**FORT CALHOUN STATION**  
**TECHNICAL EVALUATION REPORT**  
**ON THE IPE SUBMITTAL**  
**HUMAN RELIABILITY ANALYSIS**

**FINAL REPORT**

Final Report, September 5, 1996

Figure 2-1. Decision tree for selection of model.

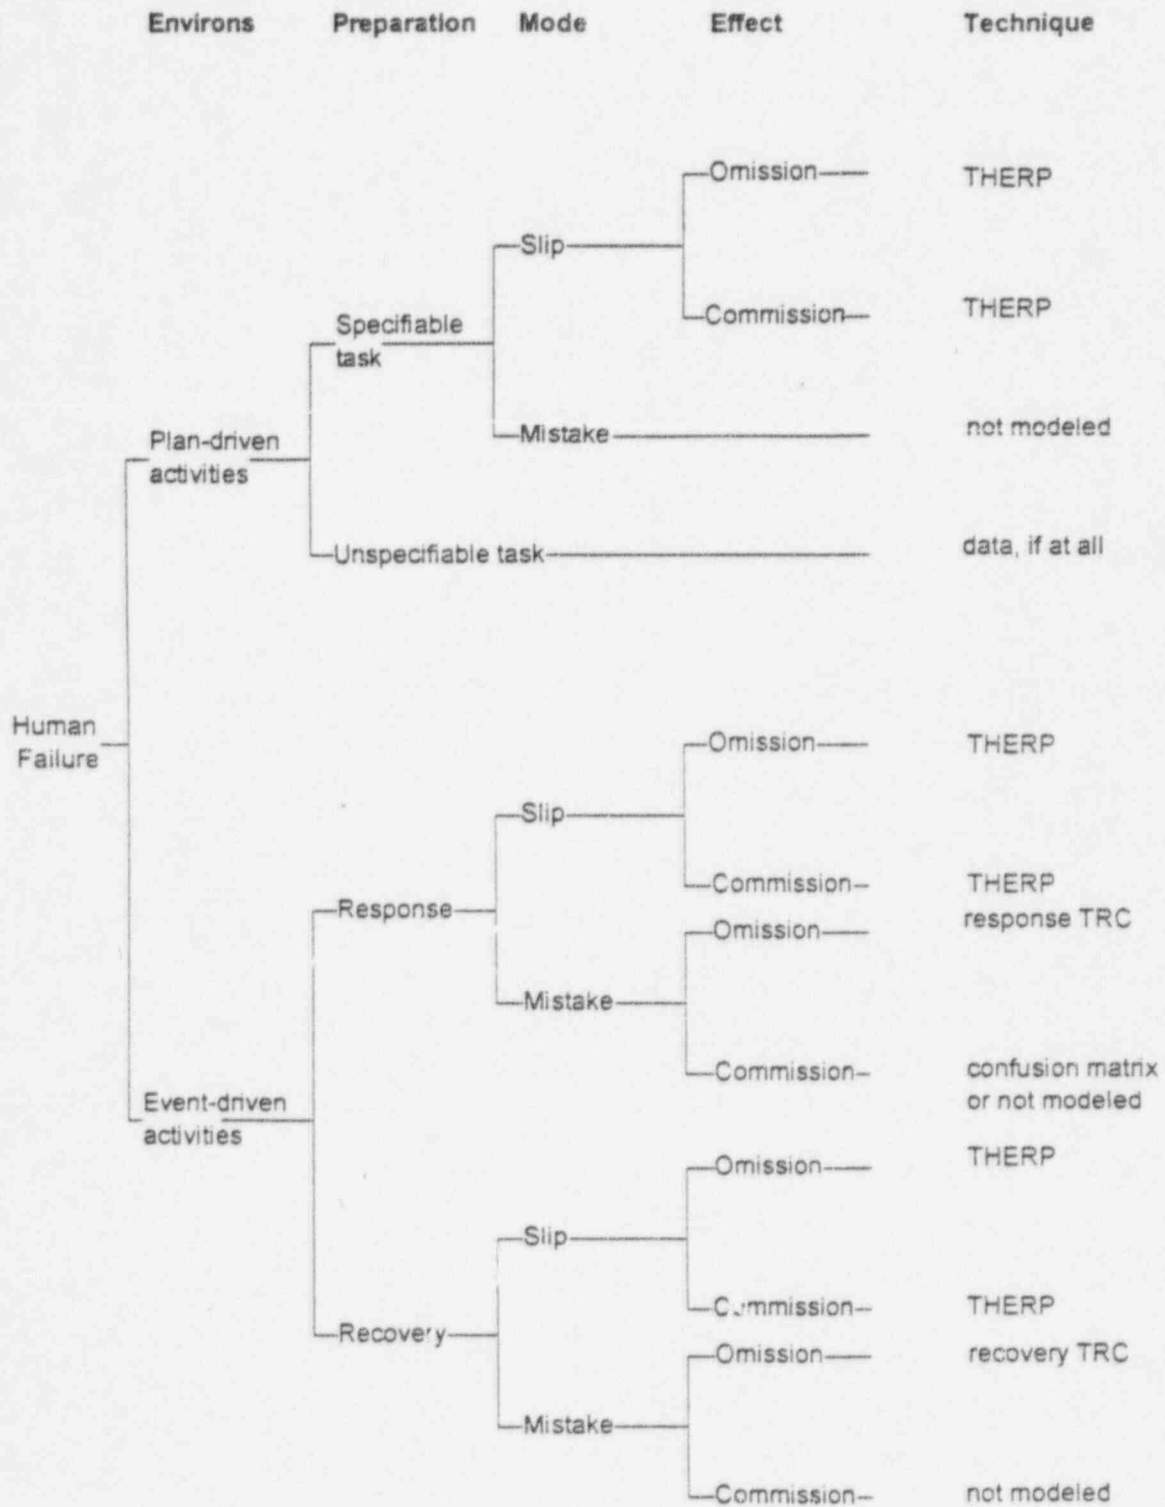
In addition, no modeling of errors of commission associated with mistakes in the "event-driven activities" was performed in the FCS IPE. The confusion-matrix method identified in Figure 2-1 is a technique that allows an analyst to specify the likelihood of misdiagnosing some event "x" as event "y" based on such factors as the similarity of indications and alarms; it was developed by Potash for use in the Oconee PRA performed for the U.S. Nuclear Safety Analysis Center (NSAC) and is described in [7]. Since the U.S. nuclear industry's adoption of symptom-based emergency operating procedures, no PRA has used this method because of the perceived lack of need to model operators' errors in diagnosis.

The licensee does not describe the logic applied to decide which post-initiator actions should be modeled as slips and which as mistakes. Figure 2-1 identifies the selection of an appropriate model for quantifying slips and mistakes, but does not describe the choice between a slip and a mistake for any particular action. Since using the different models can lead to significantly different probabilities of failure, the lack of guidance as to whether to select an action as a slip or a mistake is a potential limitation in the method and in the IPE.
